APPENDIX 6

Responses to Commission's Questions from Proponent and Agencies

Wallarah 2 Coal Project

1 RESPONSE TO DP&I ISSUES

FIGURE 1

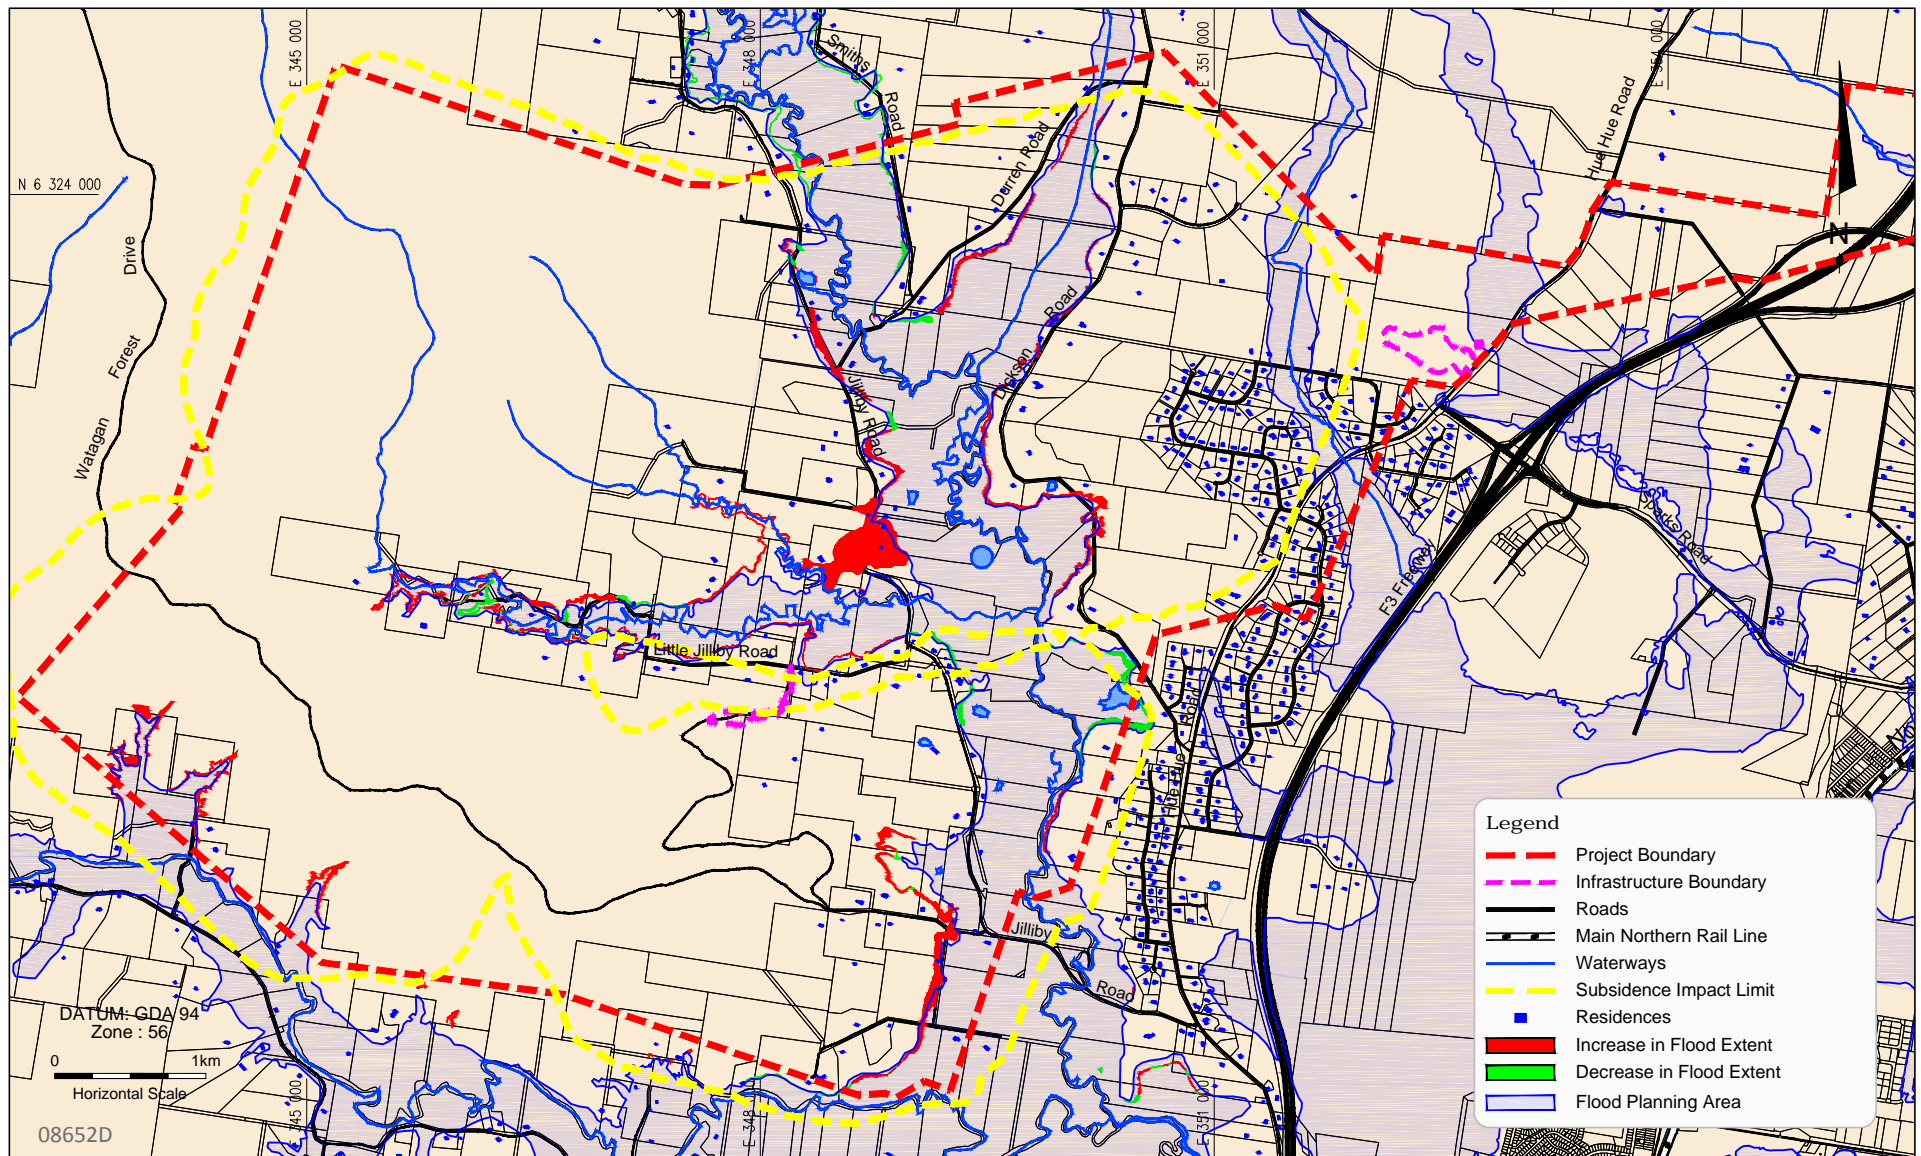
The Flood Impact Assessment has assessed the changes to flooding impacts on existing structures. The Project will cause some areas that are currently outside the 100 year ARI flood extent to become flood affected. The ability to build structures in these areas would be affected. What is the impact on the potential for future structures in areas that become flood affected as a result of the Project? How will WACJV manage these impacts?

The Flood Impact Assessment (GHA, 2013) assessed the change in the 100 year ARI flood extent due to subsidence. This assessment predicted that the post-mining flood extent would increase in some locations and decrease in other locations. Figure 34 of the EIS identifies the areas where the flood extent will increase due to subsidence. These areas are currently outside the 100 year ARI flood extent but are predicted to become flood affected after subsidence occurs. These areas are shown in **Table 1**.

As shown in **Figure 1**, some of the areas that are predicted to become flood prone are within the designated flood planning area. Under existing conditions, development in these areas can only be carried out if the conditions in clause 7.2 of the Wyong LEP are satisfied. The same conditions will need to be satisfied after subsidence has occurred. Therefore, the Project will not affect the ability to develop on this land.

However, there is also land outside the designated flood planning area that is predicted to become flood prone. There are multiple properties containing land that is predicted to become flood prone. However, the increase in the flood extent only accounts for a small portion of most of these properties. Accordingly, the Project is unlikely to preclude development on these properties.

There are only two privately owned properties where the increase flood extent accounts for a significant portion of the property area. These are located on low sloping land near the confluence of Jilliby Jilliby Creek and Little Jilliby Jilliby Creek. The Project may affect the potential for future development on these properties. However, both these properties contain existing dwellings. As such, it is less likely that the owners would have intentions of constructing further structures on these properties.

Figure 2
Subsidence Zones and Alluvial Groundwater Flows to Area Above LW5N

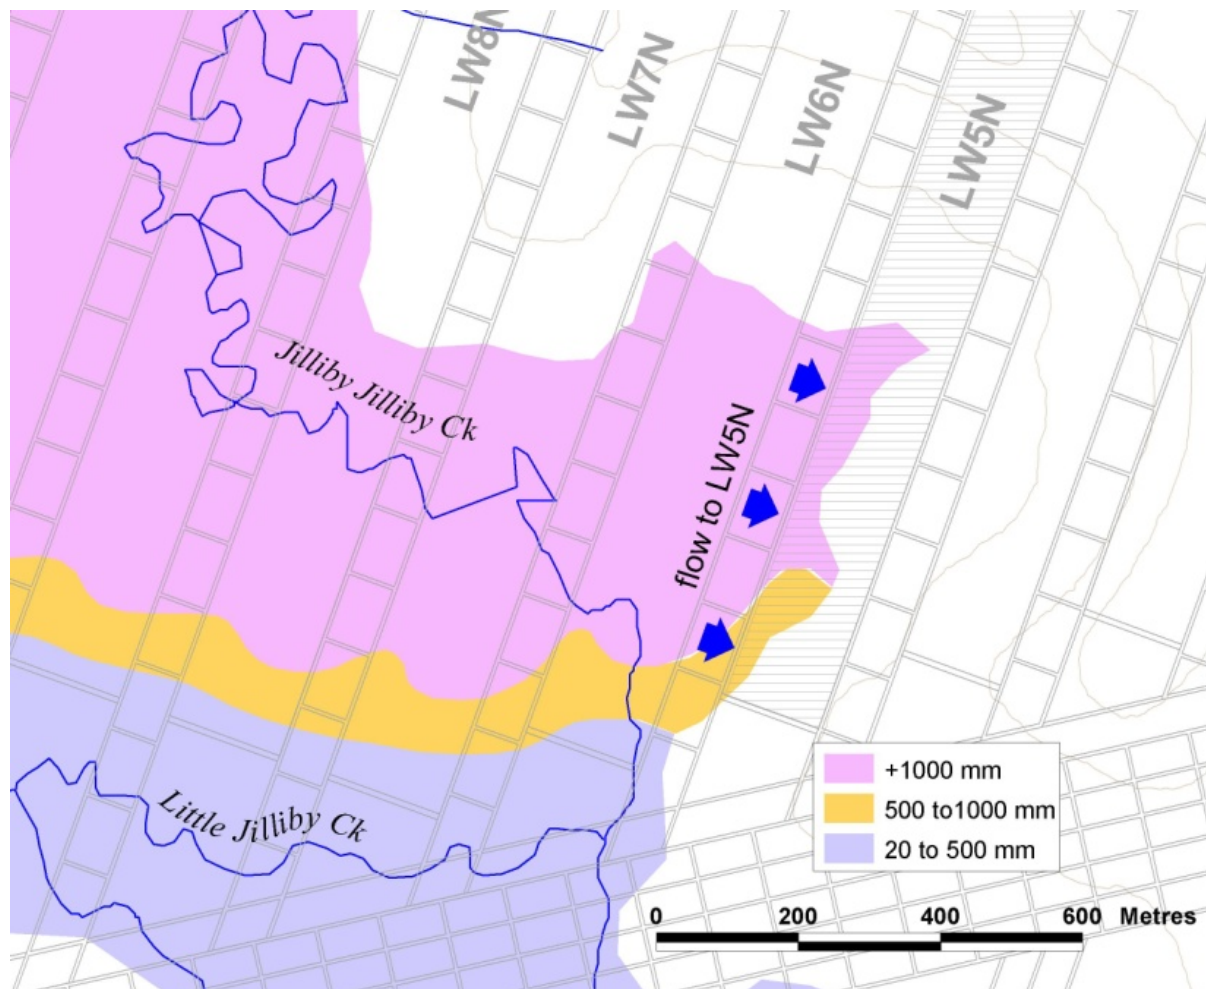
Subsidence of alluvial lands will temporarily increase the storage capacity of the alluvium. During the temporary increase in storage, a greater volume of rainfall and runoff may infiltrate into the alluvium. If this water is ultimately discharged into Jilliby Jilliby Creek, the additional infiltration of surface runoff is a transient diversion rather than a real water loss.

In the Dooralong Valley, this process will be first evident in LW5N (see **Figure 2**). As LW5N is extracted, groundwater will flow from the alluvium above the unmined LW6N to the subsided alluvium above LW5N, resulting in a lowering of the alluvial water table above LW6N, which will be replenished by rainfall recharge. The maximum redirection of runoff into alluvial storage is approximately equivalent to the subsided porous storage which has been estimated at 29ML for LW5N (refer to Table 4 of the Groundwater Impact Assessment).
